PUBLIC INTEREST REVIEW FOR GROUND WATER APPLICATIONS

SUBJECT: Application G- 17010 Supersedes review of _____
Date of Review(s)

A. GENERAL INFORMATION: Applicant's Name: WIPJRI, LLC County: Marion

A1. Applicant(s) seek(s) 0.78 cfs from 3 well(s) in the Pudding and Mill Creek Basins,
Willamette River subbasin Quad Map: Stayton NE

Well Location Map (Shows only a partial representation of geologic structures. Refer to original USGS maps for details).

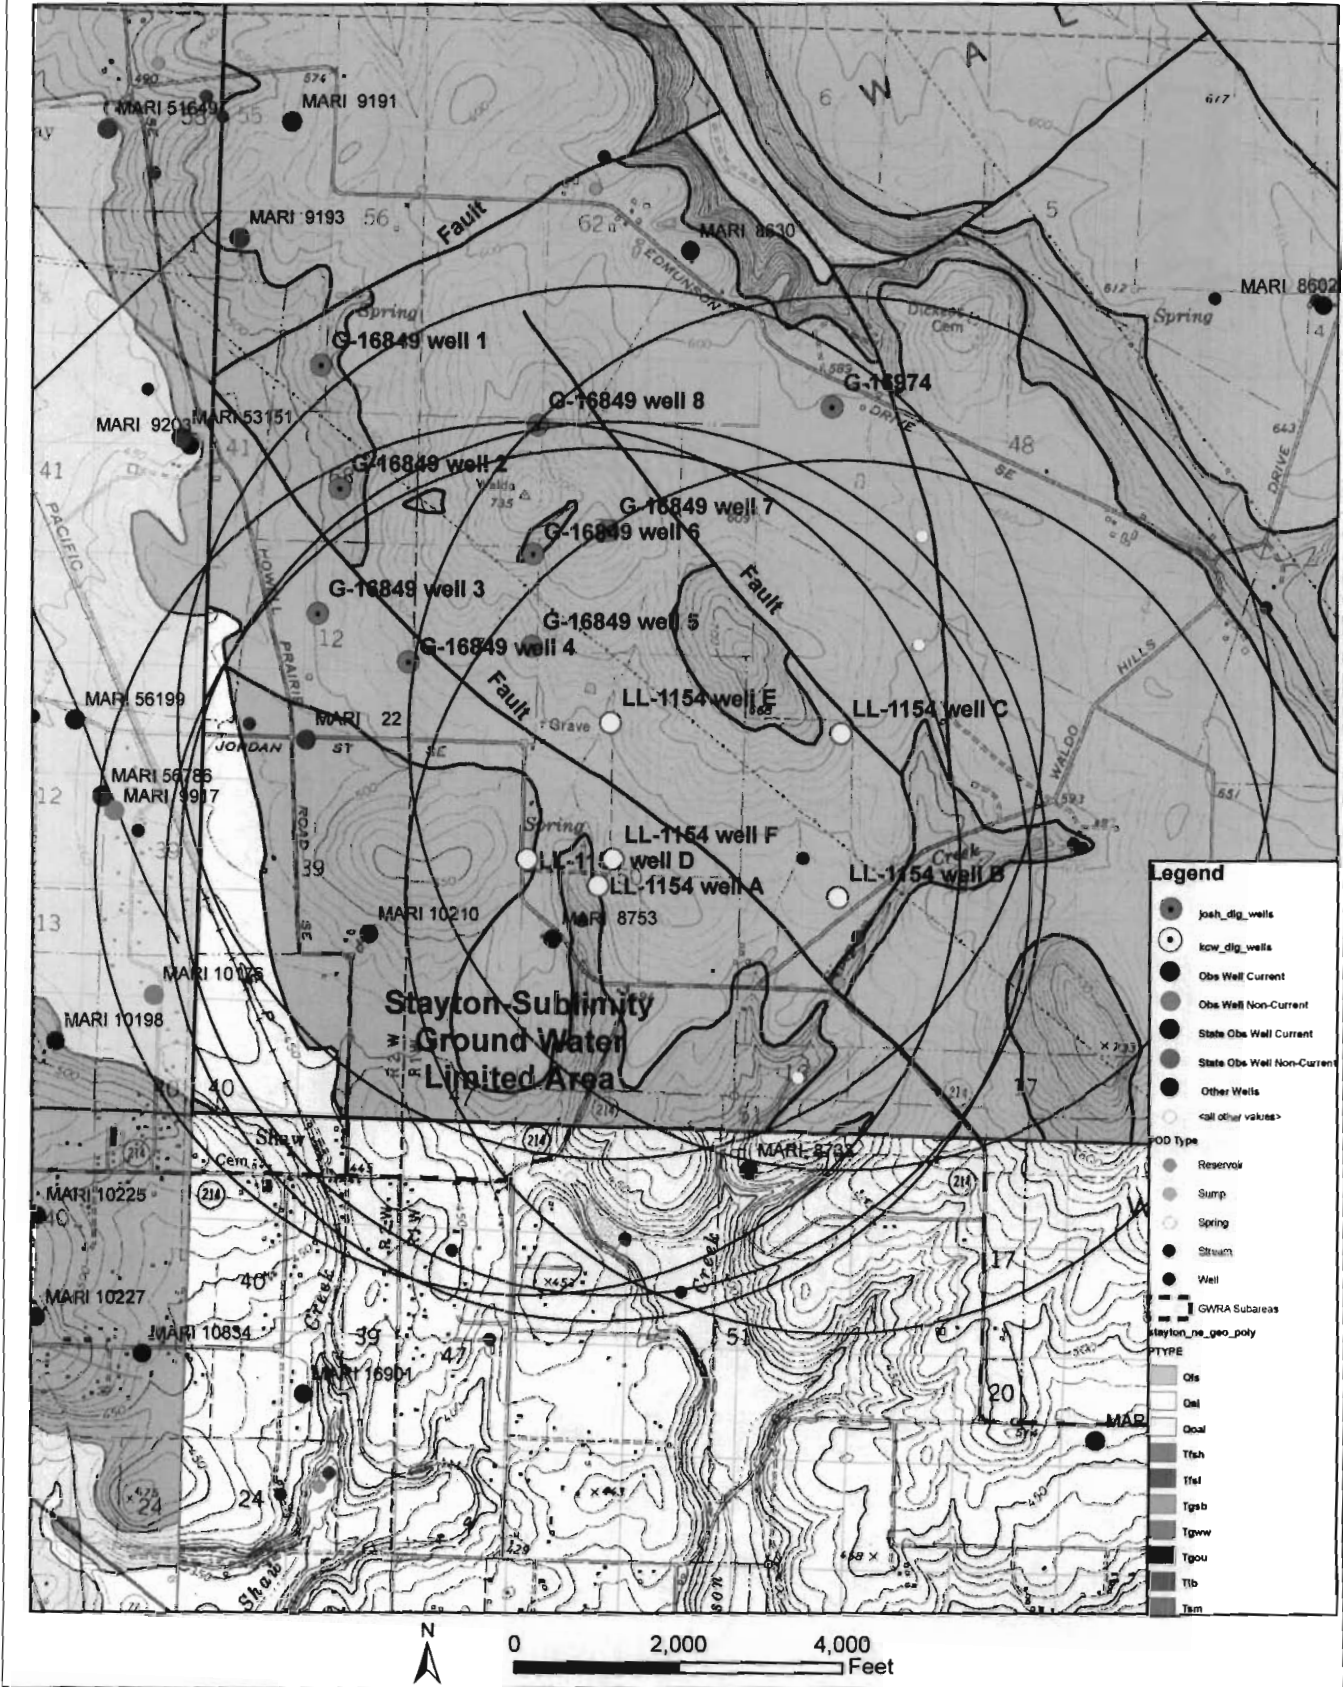
Proposed well 1 (A) and proposed wells D and F on LL-1154 fall on the same side of a northwest-trending geologic fault as permitted irrigation wells MARI 22 and MARI 56786. Water level data in a nearby observation well, MARI 56199, indicate a seasonal fluctuation of at least 80 feet (see attached plot). Most of this seasonal variation is probably caused by hydraulic interference from MARI 22 and MARI 56786 which are the nearest irrigation wells in the same fault block. The long-term water-level trend in MARI 22 suggests that water levels have declined about 6-8 feet from the early 1990s through 2007 although much of this may be related to precipitation trends over the same period of time. This hint of instability and the large hydraulic interference that occurs seasonally on the south side of the fault suggest that excessive hydraulic interference is likely in existing wells if three additional large-capacity irrigation wells are permitted in the same area on the south side of the fault. (If the fault is a barrier to horizontal flow, as seems likely, it will increase the mutual interference between wells on the same side of the fault). The presence of the fault is also likely to result in greater impacts within the Stayton-Sublimity Ground Water Limited Area which is less than 1 mile to the south of proposed well 1(A) and wells D and F on LL-1154. Therefore, it is recommended that only one of the three wells be allowed with a production limit of 200 gallons per minute. Phone conversations with the applicants' agent, Ken Johnston, indicate that the applicants would prefer to drill proposed Well D if only one of the three wells is allowed. Therefore, it was determined in Section B1 that water is not likely to be available from proposed well 1 (A) without injury to prior water rights.
